MEMORANDUM

SUBJECT: Review Comments, 2013 Draft FCRPS Supplemental Biological Opinion

In response to your request the Fish Passage Center (FPC) staff have reviewed the hydro systems operations portion of the NOAA 2013 Draft FCRPS Supplemental Biological Opinion (herein referred to as Draft BIOP) and the three supporting documents: (1) "Federal Columbia River Power System Improvements and Operations under the Endangered Species Act — A Progress Report" by the Bonneville Power Administration based upon analyses by BioAnalysts Incorporated and Anchor QEA LLC, (2) "Limitations of Correlative Investigations of Identifying Causal Factors in Freshwater and Marine Survival of Columbia River Salmonids" by Skalski et al. (2013), and (3) "Review of Assessing Freshwater and Marine Environmental Influences on Life-Stage-Specific Survival Rates of Snake River Spring–Summer Chinook Salmon and Steelhead" by Manly (2012).

Figure 1. The grey bars are the adult counts at Lower Granite Dam for hatchery steelhead from 2000 through 2012; the grey line is the geometric mean. The red line is the combined geometric mean of spawning populations for the John Day and Deschutes River basins from NMFS (2009 Appendix A).

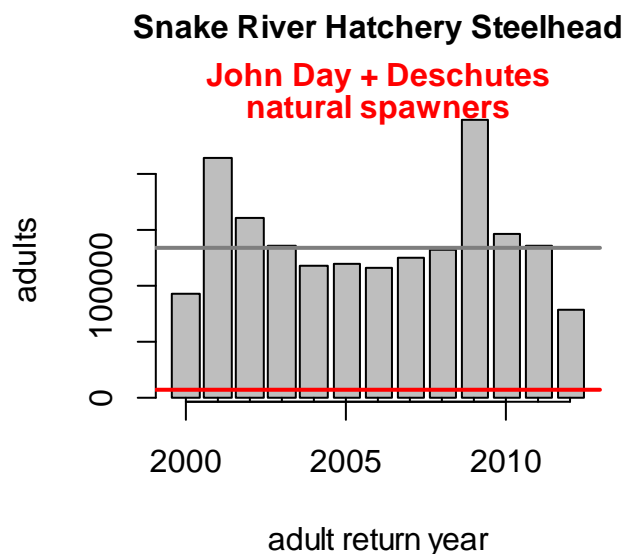
- Increasing the proportion of transported fish will increase the population of Snake River hatchery adults that stray above BON. On average, the returning adult population of Snake River hatchery steelhead is more than ten times the combined naturally spawning steelhead population for the Deschutes and John Day river basins, and therefore small increases in straying can potentially have large impacts on downriver populations.. NOAA has identified out-of-DPS (distinct population segment) hatchery strays as a limiting factor to the recovery of the Deschutes and John Day River steelhead populations (NMFS 2009; Appendix A).

The Middle Columbia River Steelhead ESA Recovery Plan (NMFS 2009; Appendix A) concluded that a significant portion of spawners in the Deschutes and John Day River populations were out-of-DPS strays and identified out of basin hatchery steelhead strays as a limiting factor for the recovery of these subbasin populations. Increasing the numbers of transported hatchery Snake River steelhead increases the potential impact of a large Snake River hatchery steelhead population on smaller subbasin populations (Figure 1).

Figure 2. Juvenile passage date (2011) at Lower Monumental Dam of Snake River spring Chinook detected at Bonneville Dam in 2013.

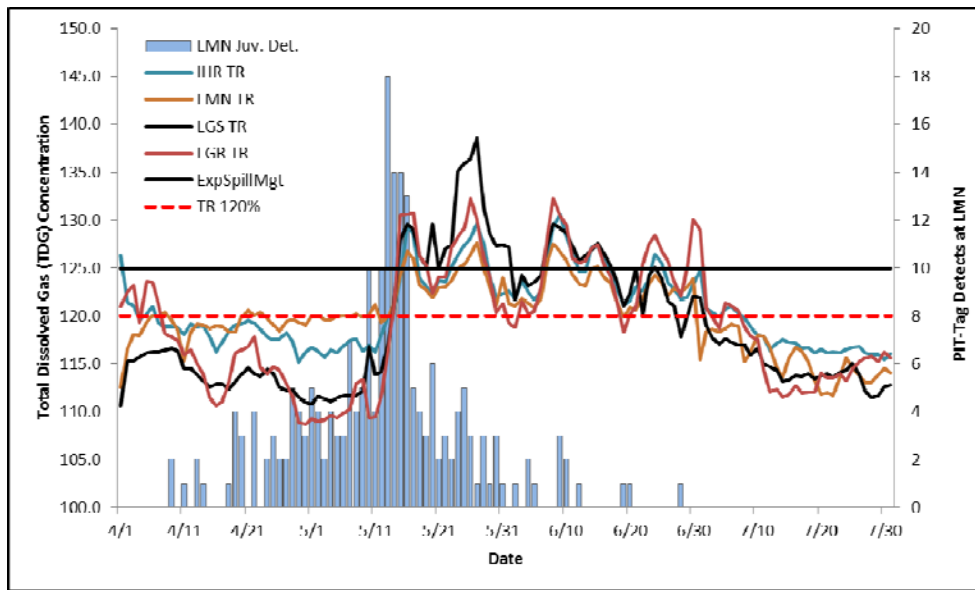
It is also important to note that implying the low adult returns from 2011 were a function of high flow and spill is not based on any analysis of the data. Figure 2 shows the juvenile passage dates at LMN for juvenile PIT-tagged Snake River yearling Chinook that were detected as adults at BON this year. While over 60% of the returning PIT-tagged adults that were detected at BON this year passed through the Snake River as juveniles when TDG was below the current States' standards of 120% in the tailrace, the other 40% were migrating in the Snake River when TDG levels exceeded 125% and, at some projects, exceeded 130%. This suggests that NOAA has made the statement in the Draft BIOP prematurely and their dismissal of the Experimental Spill Management on the basis of the low returns from 2011 is unfounded.

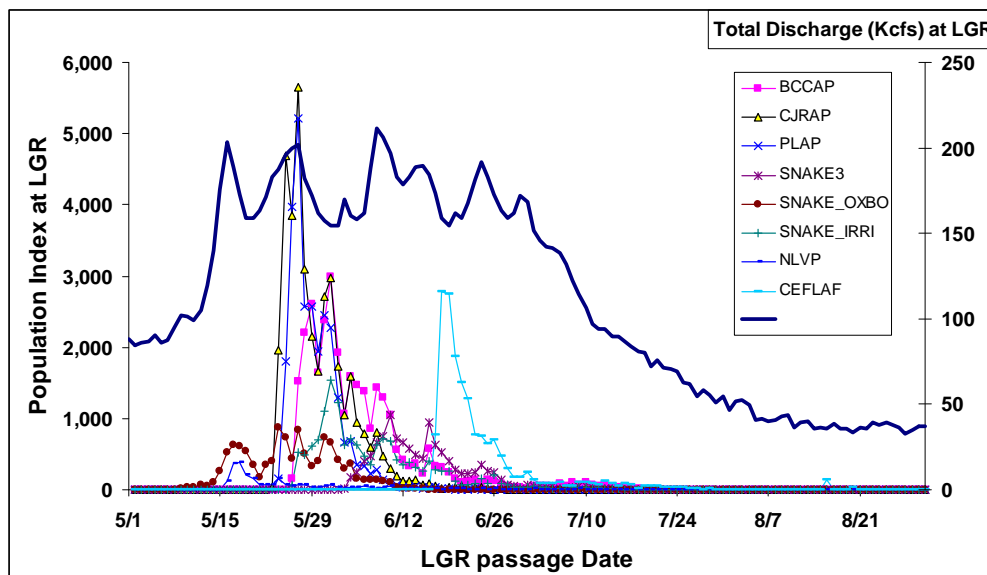
Additionally, the record returns of fall Chinook to the Snake River were predominantly (about 60% based on PIT-tagged adult fish at BON) from 2011 juvenile outmigrants returning as adults. The juvenile passage timing for subyearling migrants was earlier than average and reflected the high flow conditions (Figure 3). More than half of subyearling migrants passed through the hydrosystem during June and the first half of July, and were subjected to the high levels of TDG.

Data are too preliminary to determine what the overall SARs for Snake River fall Chinook PIT-tag groups will be, but it is likely the SARs will be relatively high compared to other recent years. In-river fish comprise a large portion of the return. Preliminary SAR analyses of six PIT-tag release groups from migration year 2011 showed five of six groups had transport/in-river-ratios less than one indicating higher return rates for in-river migrants than for transported fish. While it is too early to make any statements about conditions and the return of fall Chinook, the information is introduced here to suggest that NOAA’s reliance on 2011 spring Chinook returns to reject Experimental Spill Management is unfounded particularly since fall Chinook, migrating during the peak of the high flow and spill event in 2011, are returning at notably high rates.

Figure 4. Total dissolved gas (TDG) concentration at each of the TDG tailrace monitors in the Columbia River Hydrosystem, and the experimental spill management level of 125%.

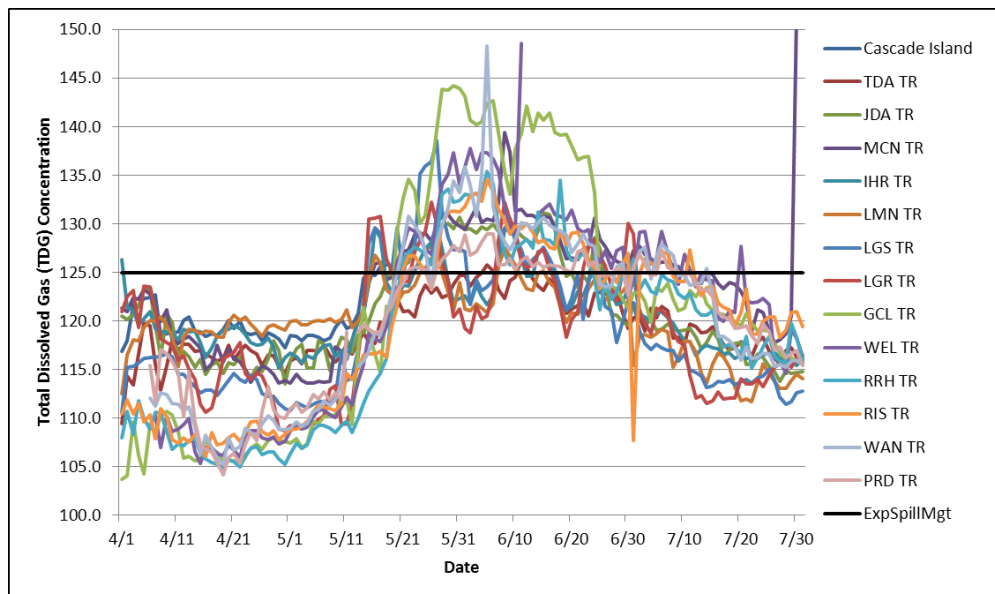
The following graph (Figure 4) shows the tailrace TDG levels that occurred through June 2011 and uses the 125% Experimental Spill Management level for reference. The 125% is the highest level considered in the Experimental Spill Management analyses for fish survival in a risk-based spill program. Consequently, comparing 2011 to what happens under a planned, voluntary spill program in Experimental Spill Management is not appropriate.

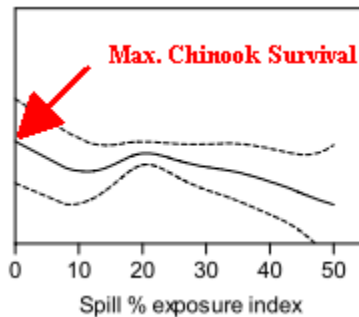
- Skalski et al. (2013) makes the comment that yearling Chinook have a maximum juvenile survival when spill is 20%, yet the model used for this same analysis predicts a maximum Chinook survival at 0% percent spill, which is obviously incorrect.

Skalski et al. (2013) references Williams et al. (2005) to note that, "For yearling Chinook salmon, survival reached a maximum at 20.6% spill." The general additive model (GAM) that Skalski et al. (2013) refers to also predicts a maximum Chinook survival when spill is zero (Figure 5). Many lines of evidence based on empirical data show that zero spill is detrimental for juvenile survival and in fact we are not aware of any other analysis available that would show that the highest possible survival would occur under zero spill operations.

Figure 6. Simple linear regressions of logit-transformed freshwater survival (S.r), ocean-adult survival (S.oe), and smolt-to-adult survival (SAR) versus average percent spill and water transit time for spring/summer Chinook salmon using data presented in Haeseker et al. (2012).

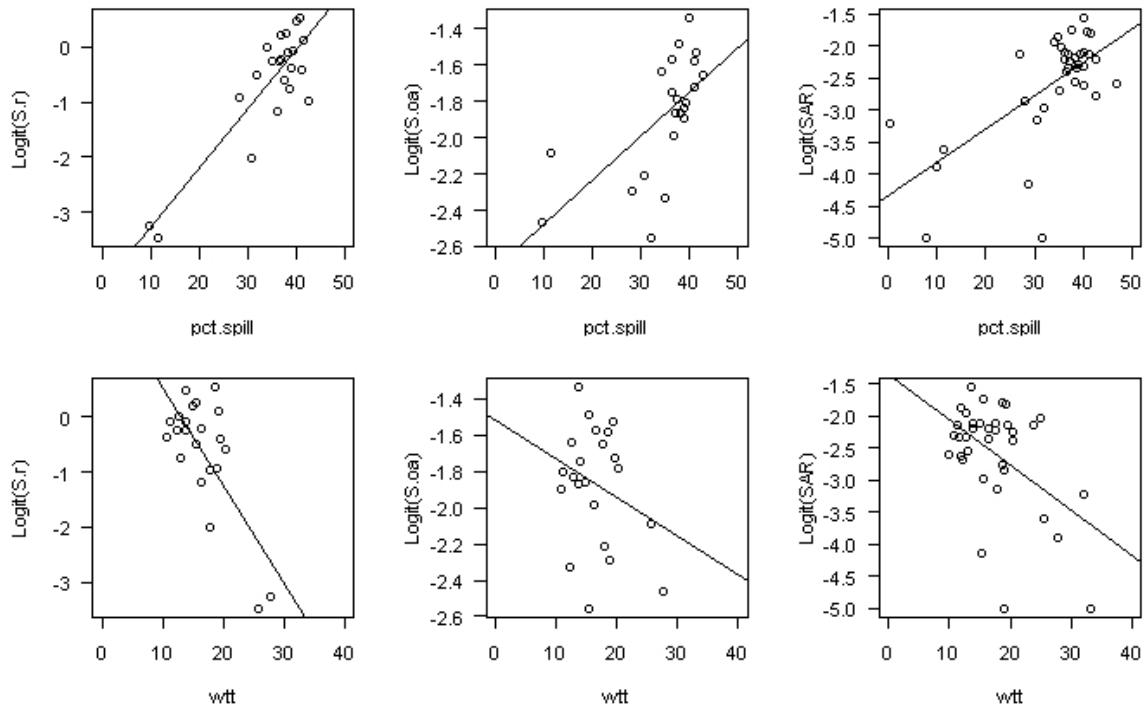
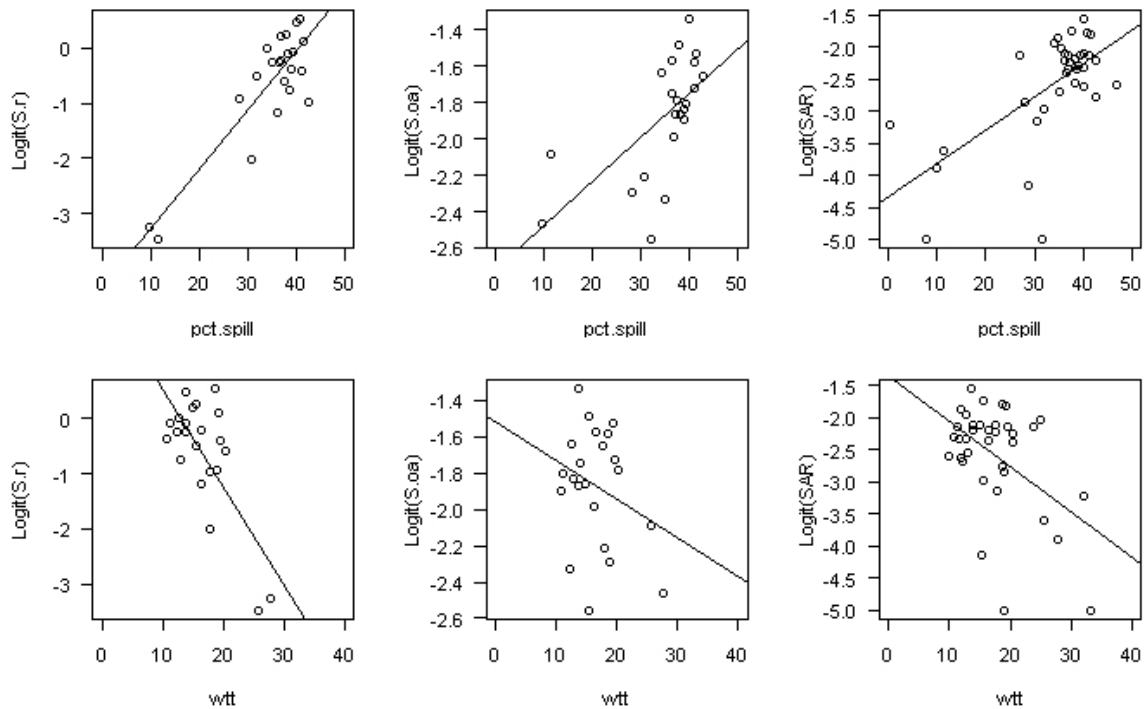
FPC used three methods to assess whether non-linear, higher-order processes or generalized additive models would have improved model fit in the data presented in Haeseker et al. (2012). First, we conducted simple linear regressions between the hydrosystem operations under management control (water transit time and average percent spill) and the stage-specific survival rates presented in Haeseker et al. (2012). These simple linear regressions suggest that there is a linear response between hydrosystem operations and freshwater survival, ocean-adult survival, and smolt-to-adult survival rates (Figures 6 and 7). These data also do not show indications of higher-order processes, optima, or thresholds. Contrary to the coarse-scale, and likely overparameterized, analysis on freshwater survival presented in Skalski et al. (2013), the data in Haeseker et al. (2012) indicate increasing survival at all life stages with increasing spill levels and reductions in water transit time (Figures 6 and 7). The data simply do not support Skalski et al.'s (2013) conclusion that survival is maximized at 35% spill levels.

Skalski et al. (2013) failed to examine whether generalized additive models would have improved model fit in Haeseker et al. (2012), despite being provided with the data to do so. In summary, the three sets of analyses presented here show that the data in Haeseker et al. (2012) support linear relationships, but do not support higher-order processes, optima, thresholds, or spline relationships for the hydrosystem operations variables under management control (spill and water transit time). Furthermore, the linear regressions presented in Haeseker et al. (2012) are likely to have less bias and better predictive performance than would be obtained by a generalized additive model approach that would suffer from overparameterization.
